Village of Bayside
9075 N Regent Road
Architectural Review Committee Meeting
May 10, 2021
Remote Teleconferencing, 6:00pm

**ARCHITECTURAL REVIEW COMMITTEE
AGENDA**

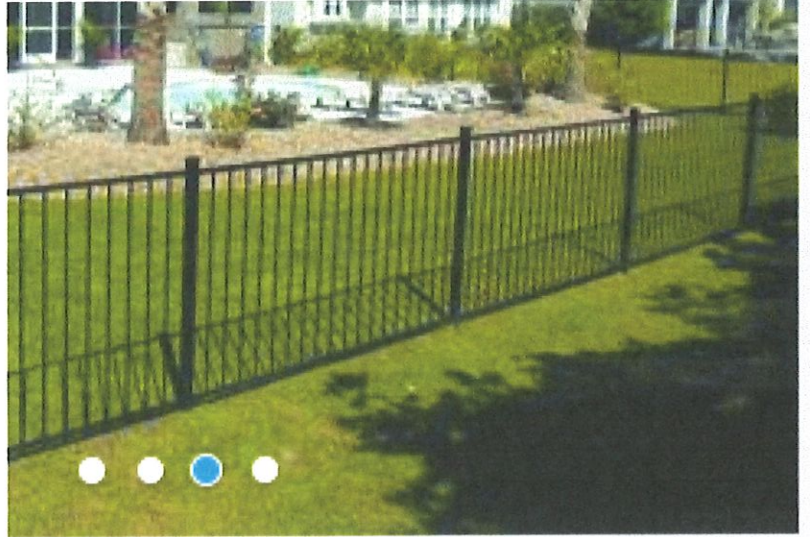
Proposed length 280' is approximately 30% of the total property perimeter length of approximately 923'.
Per the code section copied below a 25% open fence is required.

PROPOSED FENCE LENGTHS / TYPES COMPLY

PROPOSED HEIGHT IS COMPLIANT

Metal black finish

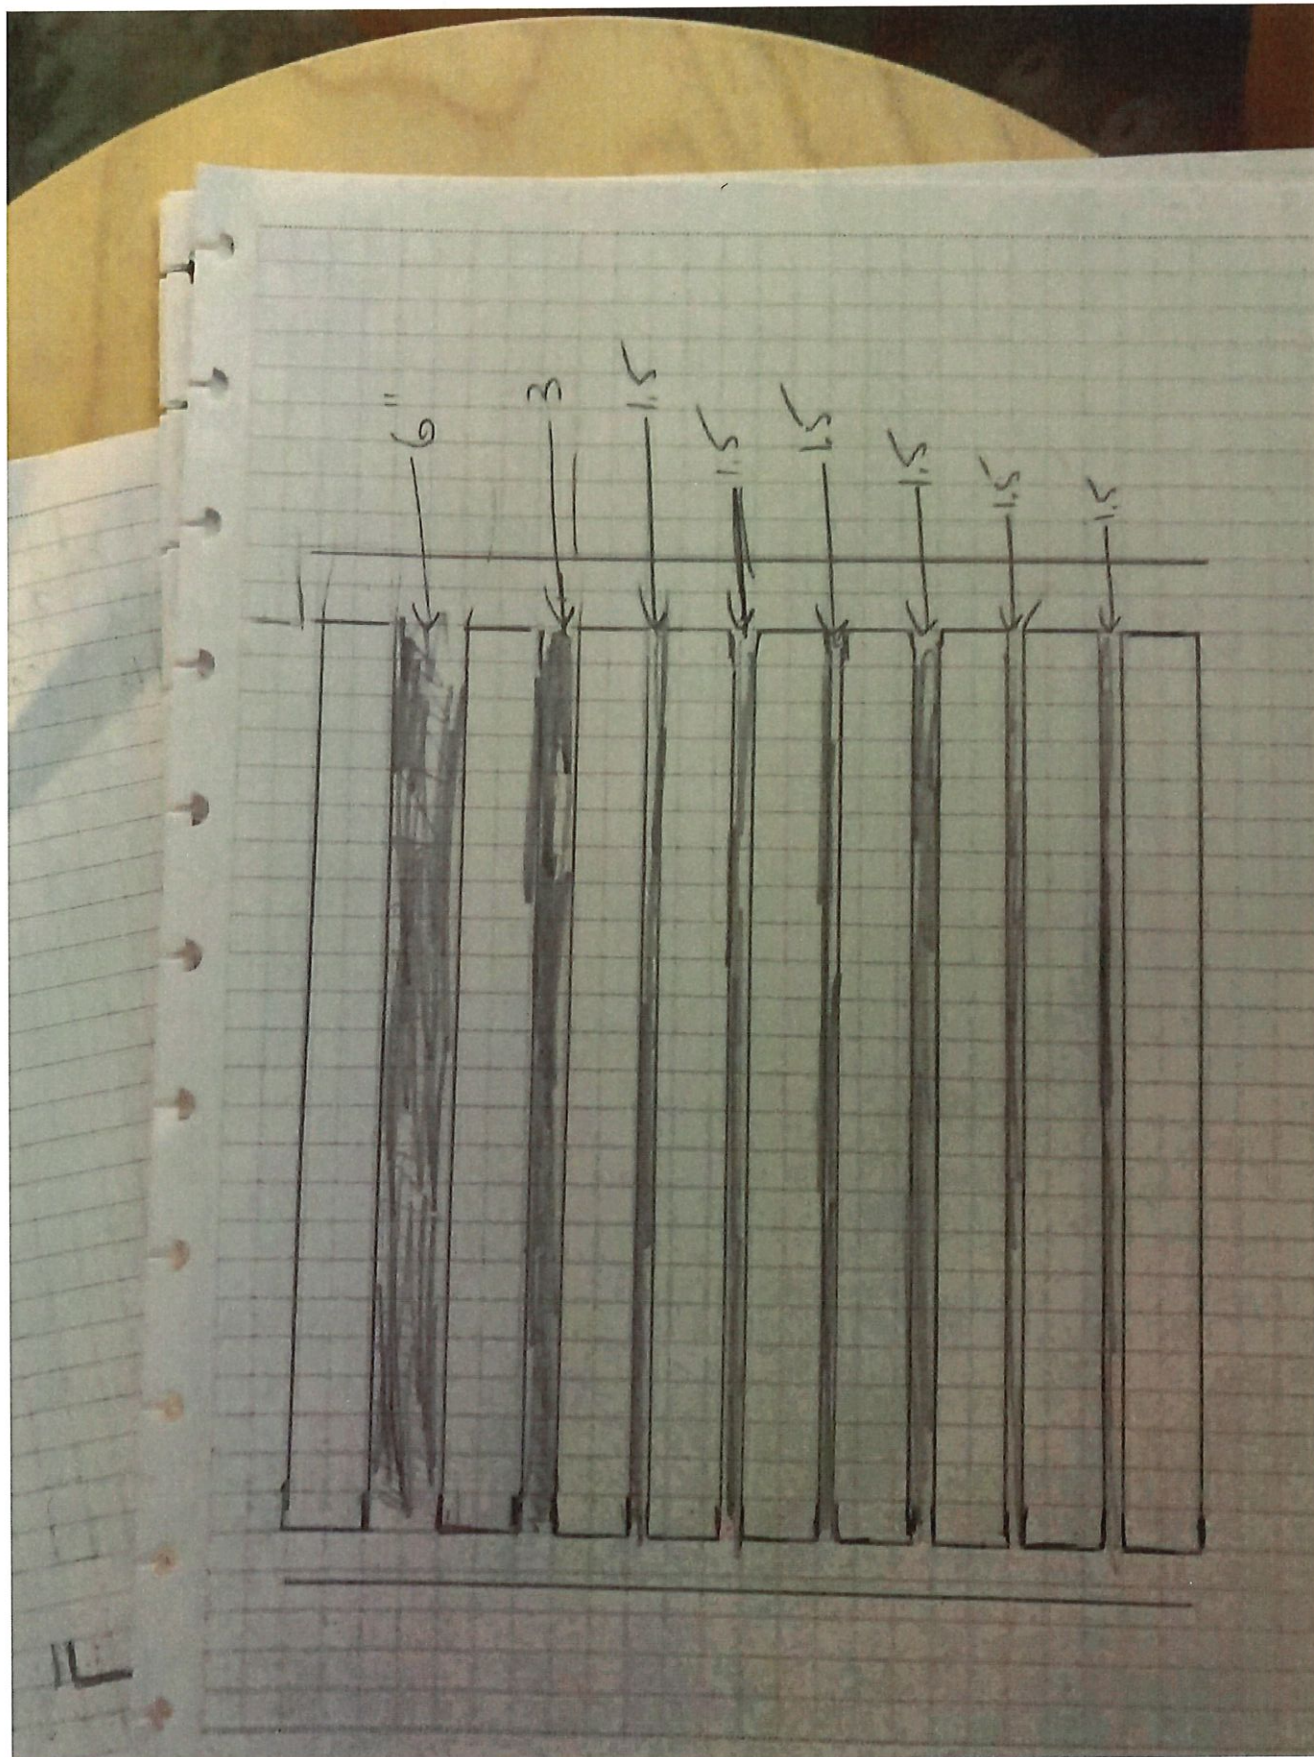
Proposed length of 276' is approximately 46% of the total property perimeter length of approximately 600'.

Per the code section copied below a 25% open fence is required.

90 feet of solid fence compliant

186 feet of 25% open fence is compliant

PROPOSED HEIGHT IS COMPLIANT

Note: The measurements of the fence must be based off of the over lay on the survey Page 10 and not the hand drawn sketch

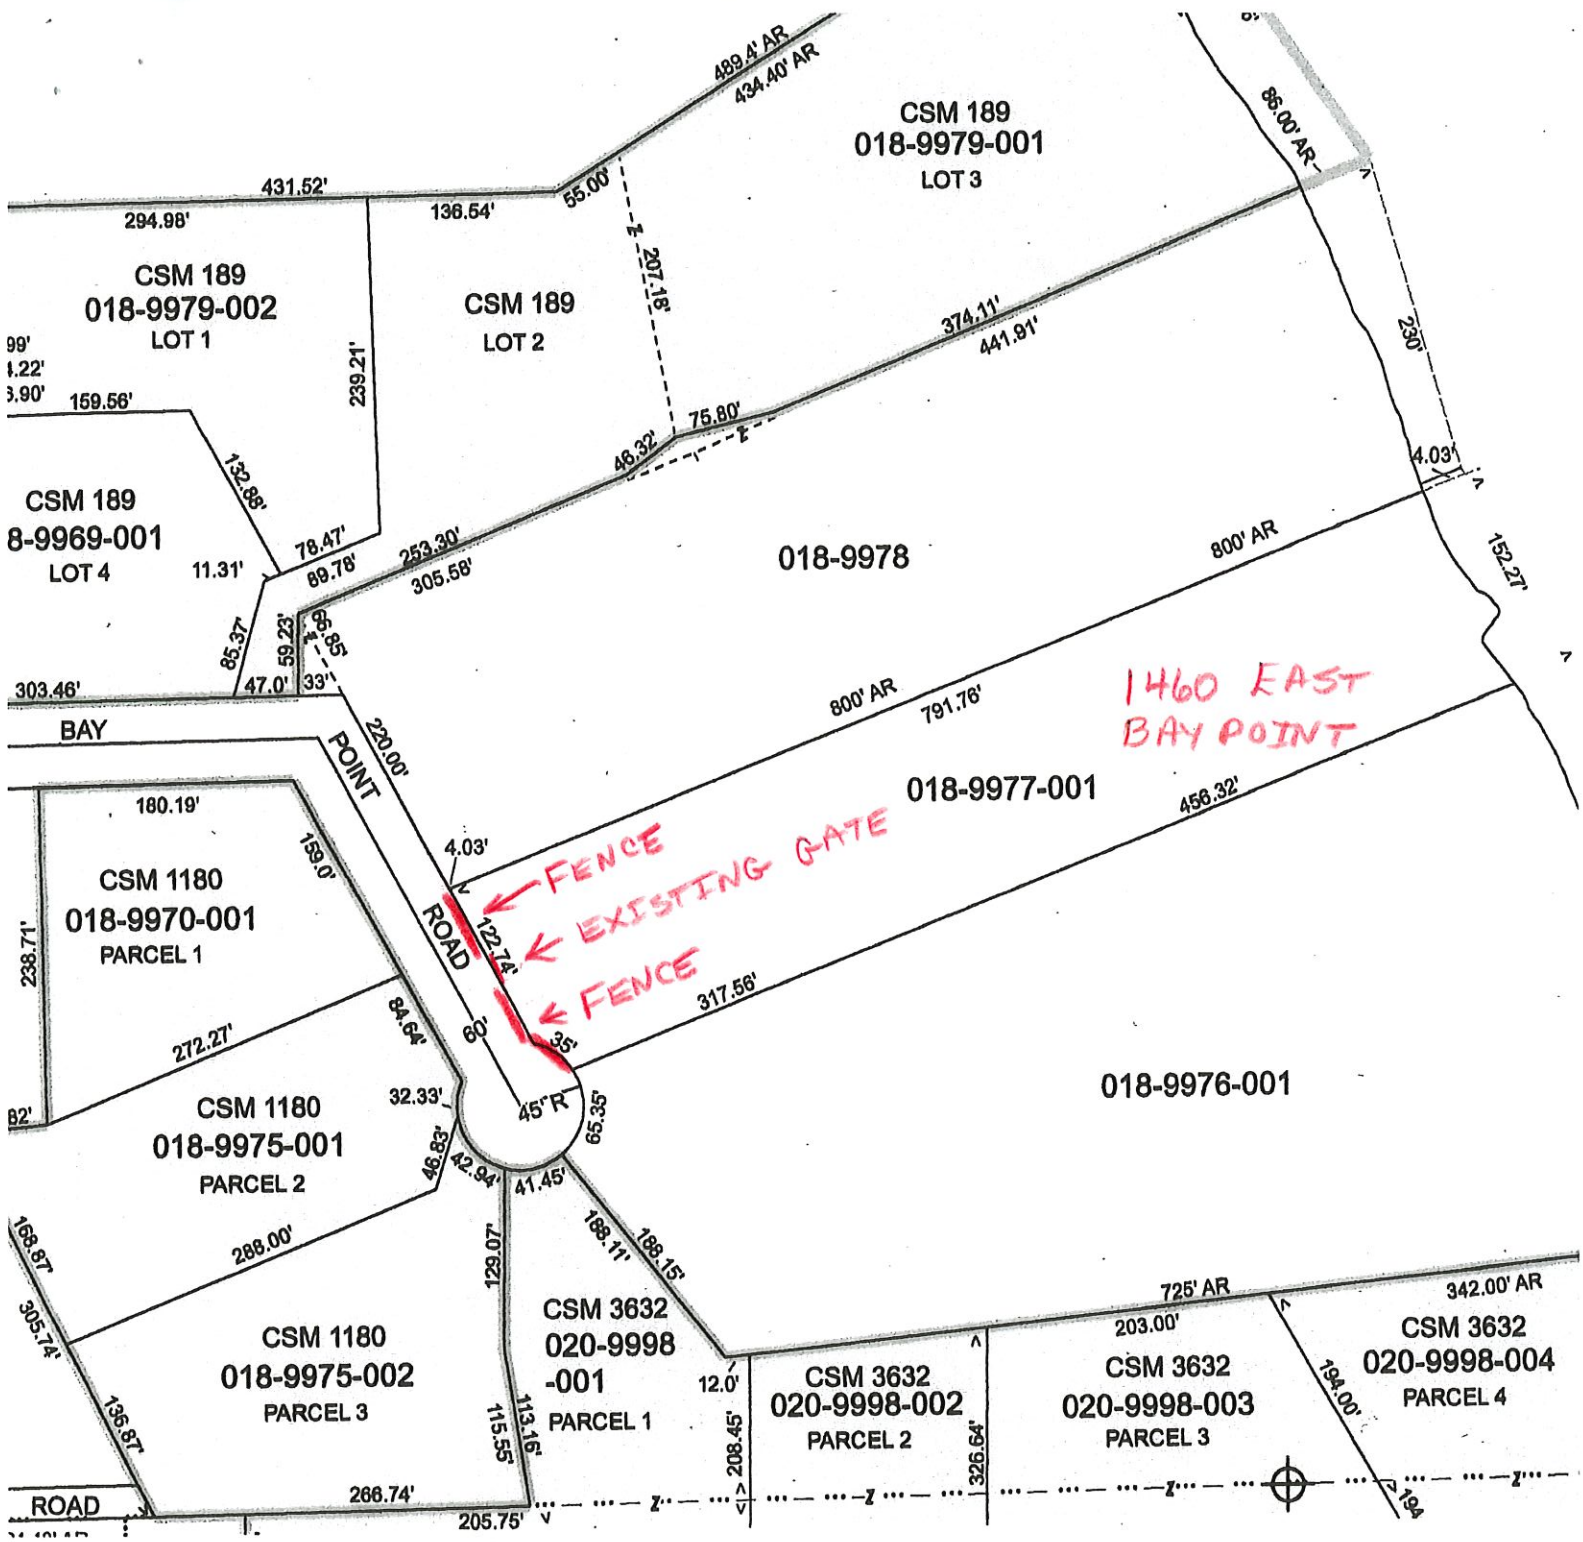
Proposed length unclear about 157' is approximately 9% of the total property perimeter length of approximately 1,882'. Per the code section copied below a 25% open fence is required.

PROPOSED HEIGHT IS NON COMPLIANT

Fences constructed within the front yard of a home shall not exceed three feet in height

Black metal requires ARC approval.
